Presentation to the Park City Planning Commission
Regarding

Base Area Redevelopment

The Responsible Resort Area Development Coalition (RRAD)

PEDESTRIAN CIRCULATION

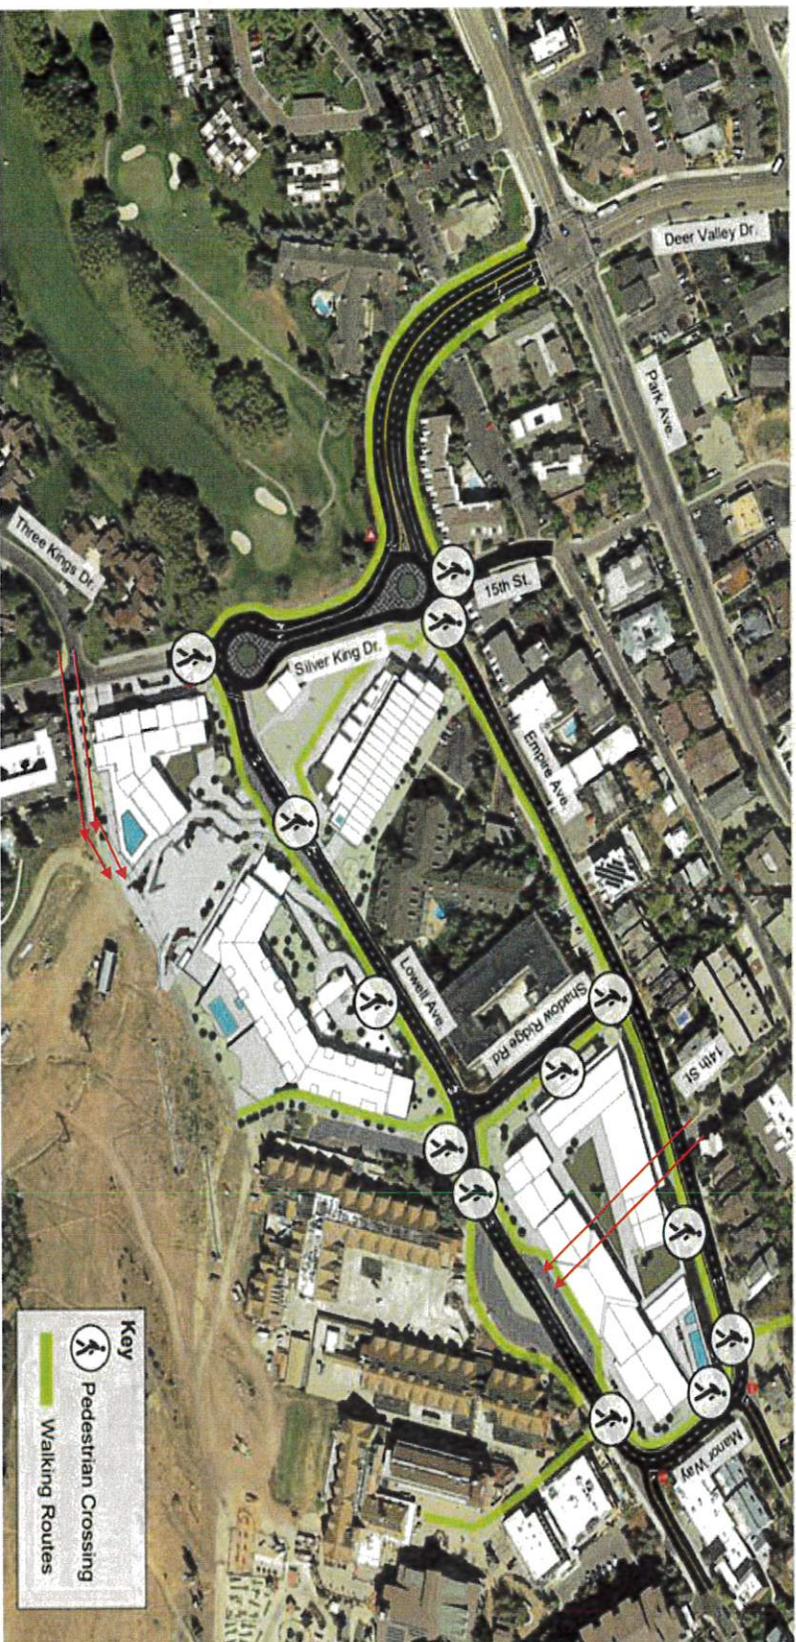
- Pedestrians from 14th must cross Empire with **NO CROSSWALK** and
- There is no 14th Street pedestrian access through Parcel B; therefore,
- Pedestrians must cross garage entrances/exits and townhome driveways around Parcel B before,
- Crossing Lowell via one of only two crosswalks to the existing resort center

- Pedestrians from Three Kings Drive must cross Three Kings with **NO CROSSWALK**
- Proceed along the north side of Silver King
- Cross over Silver King at a traffic light and finally,
- Head south along Lowell to access plaza and new or existing resort operations

Height Variance Is Not Justified – Building B Case Study

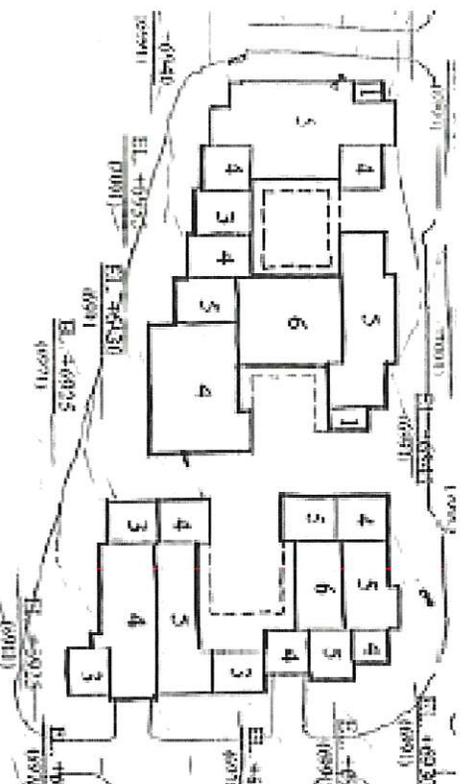
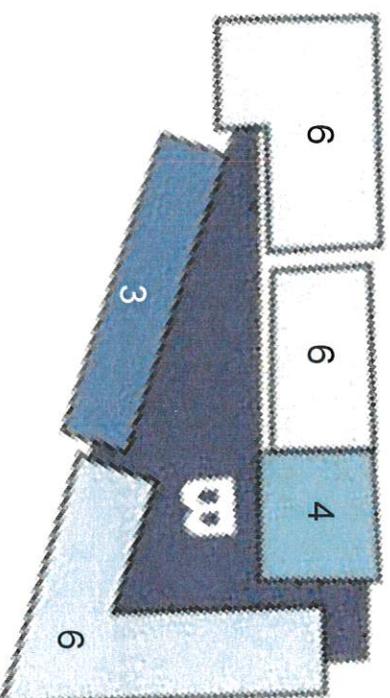
- Height limit in the RC zone is 35’
- PEG proposal averages over 80’ and exceeds 100’ in some areas (on average, more than one story taller than the 1998 Plan)
- As noted in the DA, height variances can only be granted based on a SITE SPECIFIC analysis and ONLY apply to the specific plans that were reviewed and approved at that time
- The 1998 Plan featured a SIGNIFICANT amount of architectural variation in height and massing and the MAJORITY of the height and mass was placed TOWARDS the hill and AWAY from existing residential uses

Doesn't Meet Standard for Setback Reductions

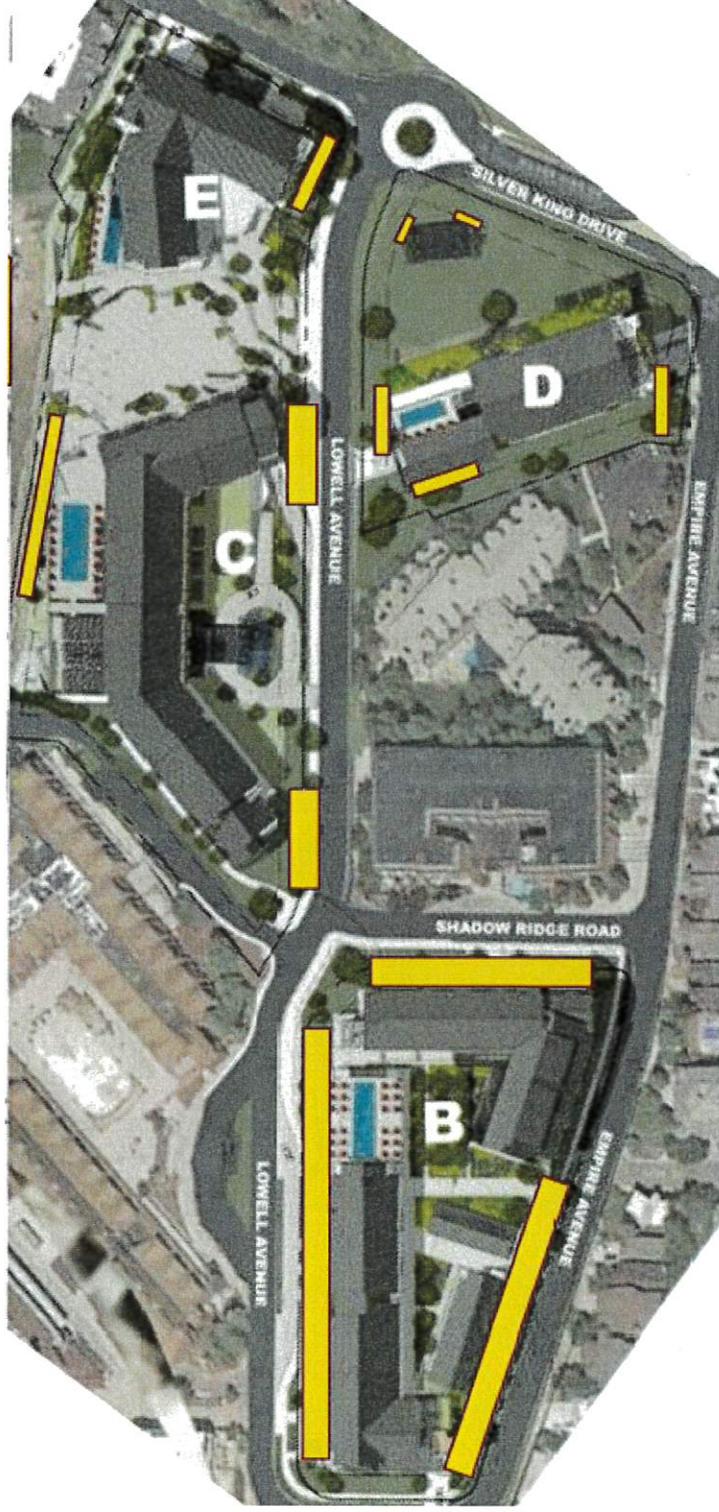
- In master planned developments, the code requires that all buildings be setback 25' from the property line; exceptions, if granted, must be no less than 20'
- PEG is requesting significant REDUCTIONS to the setbacks as seen in yellow in the illustration below
- In a project that is already unbearably dense (2-3x current zoning) and out of character for the neighborhood, this would be a crushing blow to the surrounding 2,3 and 4 story buildings
- The legal standard for setback reductions is very high – they must be NECESSARY for architectural interest and variation - and this project does not meet that standard!

Doesn't Meet Standard for Setback Reductions - Parcel B Case Study

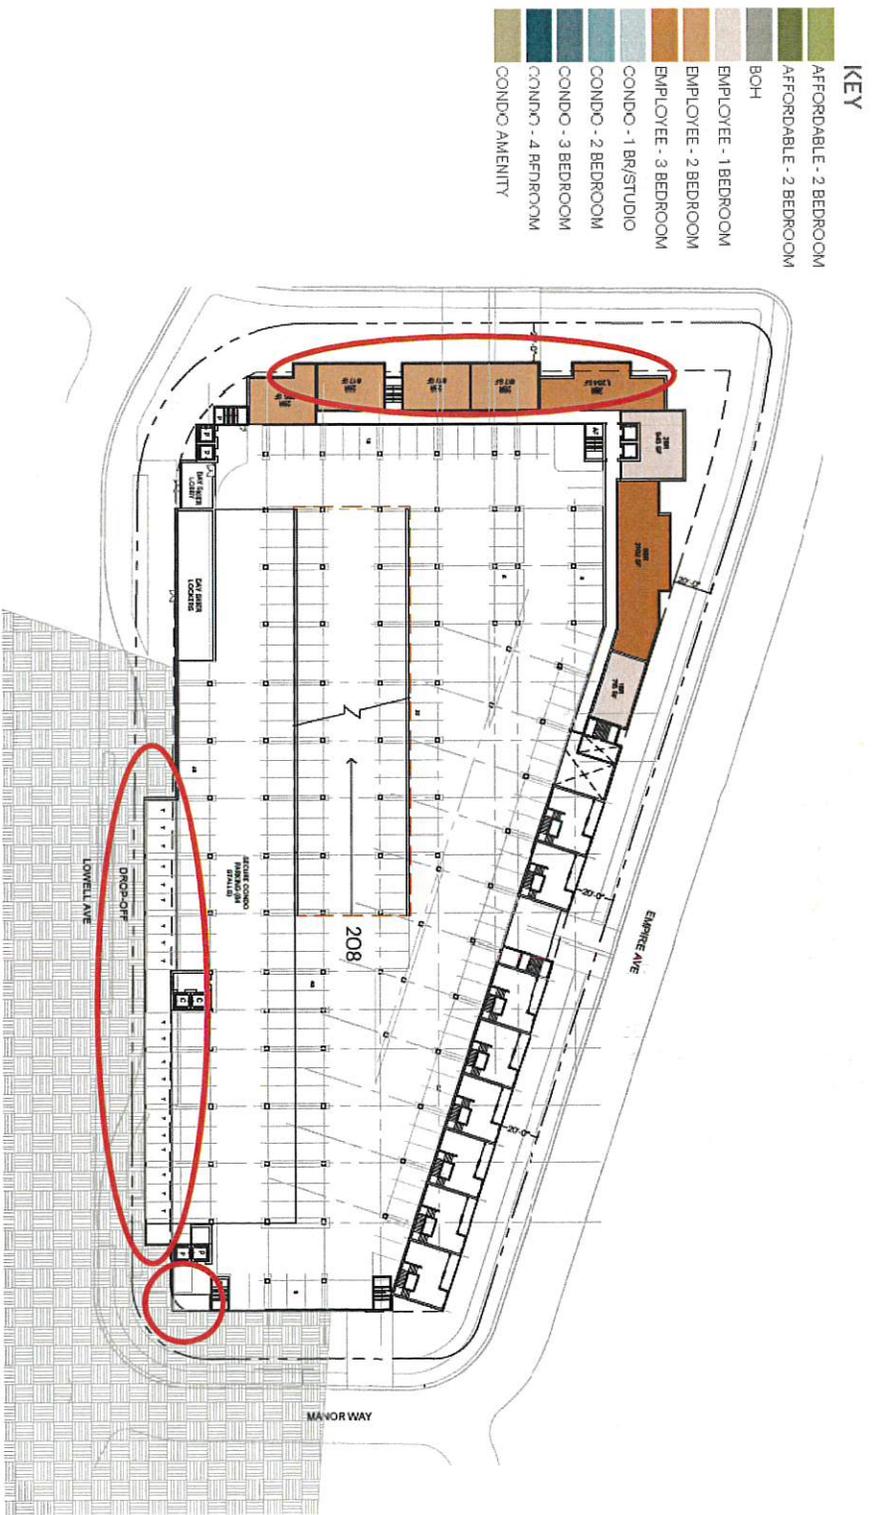
- Nearly the entire perimeter of Building B is set back 20' vs. the zone requirement 25'
- In addition, the areas in red below are set back even less than the minimum 20'

Architectural Detail Not Consistent with the 1998 DA

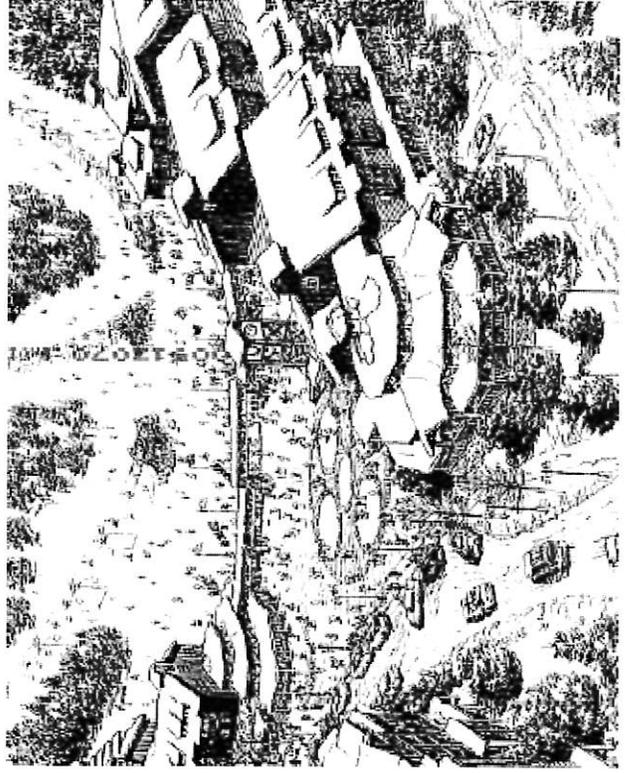
- Project a cohesive image that responds to the history and charm of the Park City area as a rustic mining town
- Architecture should look like it belongs in Park City and no place else
- Proposed entrance to PCMR major gateway feature
- Large monolithic structures are atypical in Park City
- Building heights shall step up from major roadways, public plazas and neighboring projects with higher buildings placed closest to the mountain backdrop
- The overall building volumes shall be broken up and stepped both in plan and elevation

Architectural Detail Not Consistent with the 1998 DA – Parcel B Case Study

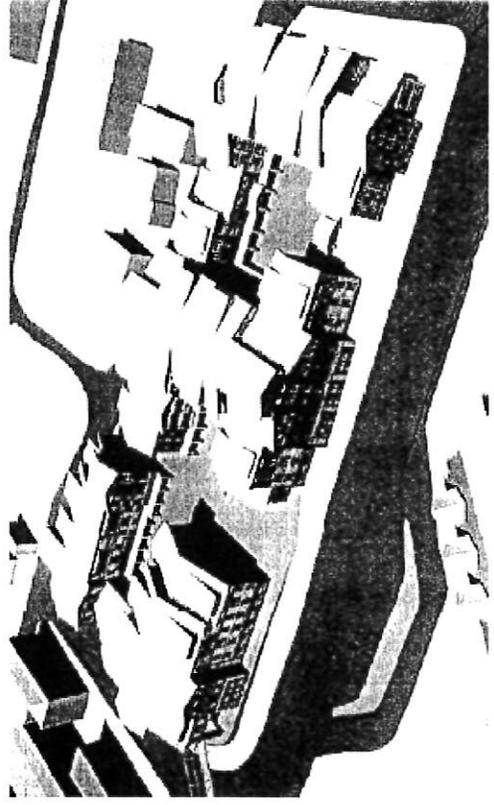
The Architectural Design Guidelines for Parcel B (below) illustrate a dramatic disconnect between the 1998 Plan and PEG’s proposal

- Parcel B is conceived as at least four separate buildings which surround semiprivate quadrangles enclosed by low-scale arcades
- Their scale is modulated by numerous steps in massing both vertically as well as horizontally from the property lines
- The parcel's bulk steps down with the contours from Lowell toward the corners of the site
- In order to minimize height and shadow impacts, the streetwall along Empire has a saw tooth plan with large setbacks: one, two and three story elements vary height and further reduce the building's scale and apparent mass
- The tallest portions of the building are located at the site's center and closest to Lowell Avenue where bulk and shadow impacts on adjacent properties will be minimized
- The concept design establishes a pedestrian and view corridor to the resort center from 14th Street

Disrespects Mandatory View Corridors

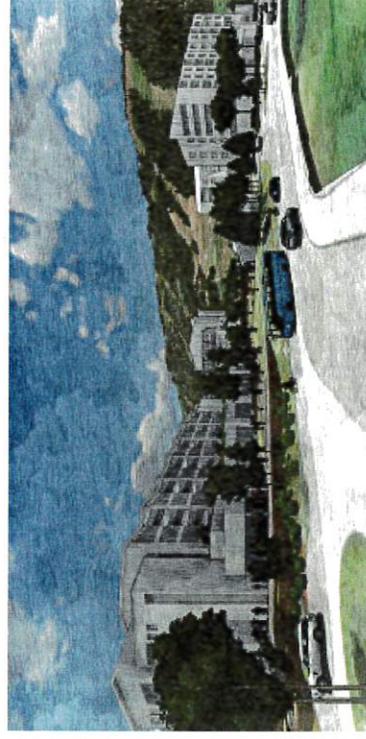
- The DA identified two critical view corridors that had to be maintained in any development – the Empire/Silver King view corridor and the 14th Street view corridor
- The Empire/Silver King view corridor has been “moderately impacted” by the PEG project’s higher overall building height, lack of modulation of building heights and minimal vertical and horizontal articulation and lack of human scale and detail

Disrespects Mandatory View Corridors

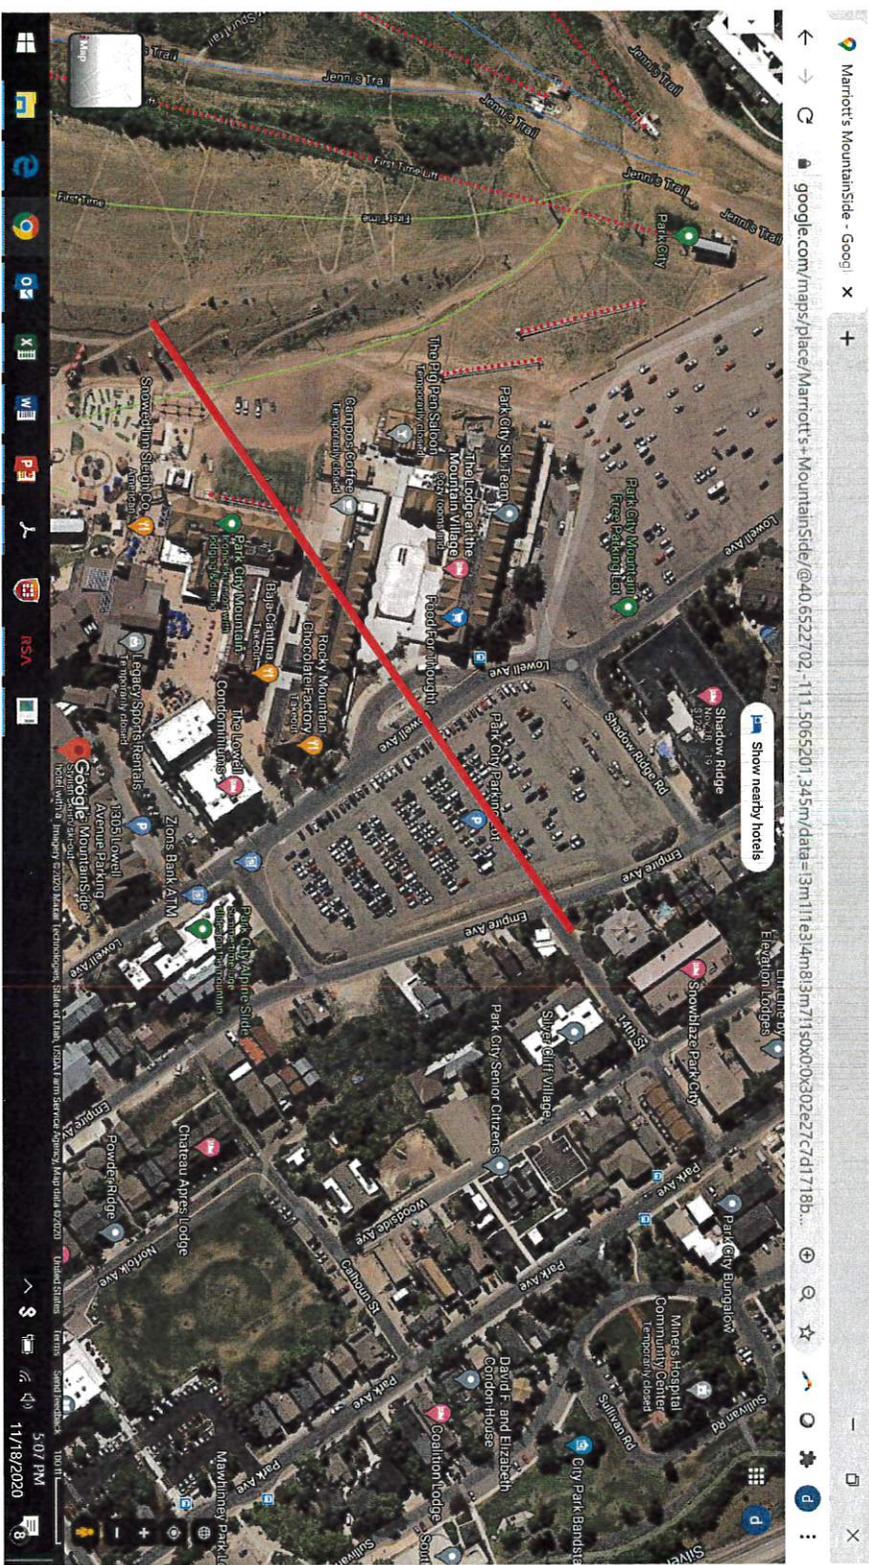
- PEG's treatment of the 14th Street view corridor is particularly troubling
- The 14th Street "corridor" is one of the most iconic pathways in the Base Area

Disrespects Mandatory View Corridors

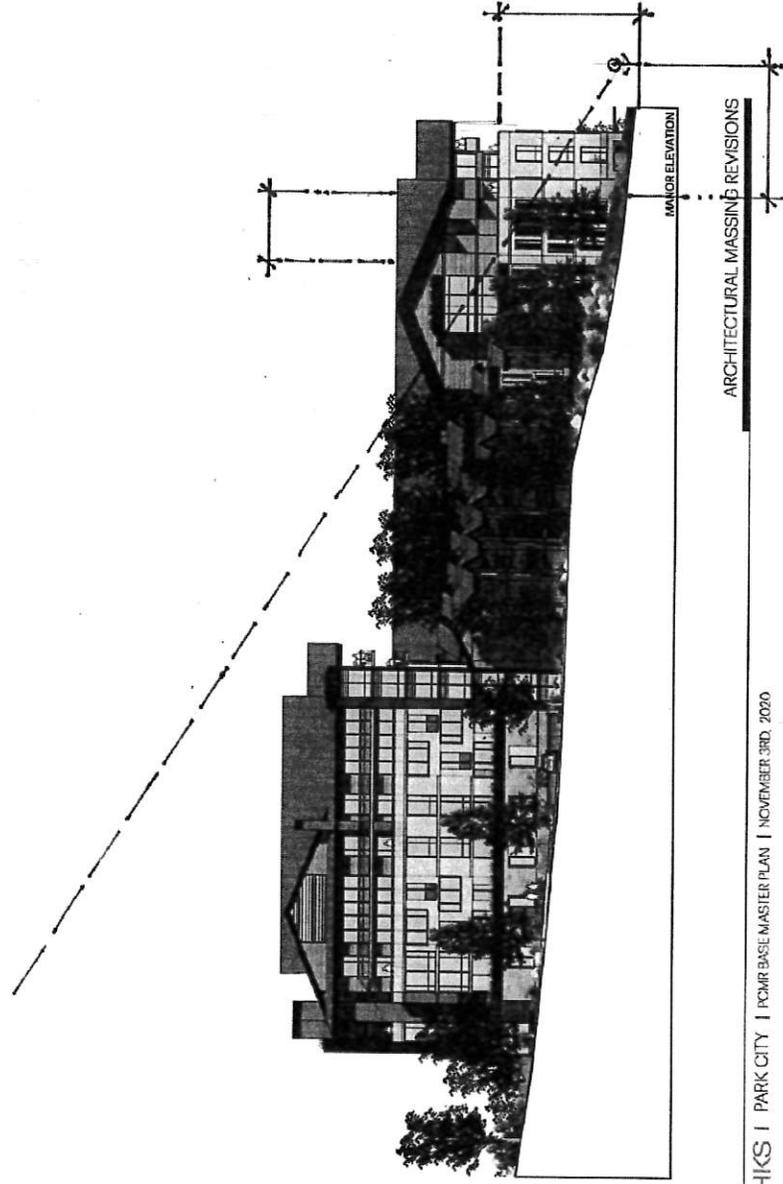
- Contrary to PEG's public remarks about "maintaining some views through Building B", there is absolutely no view corridor nor maintenance of the historic pedestrian connection
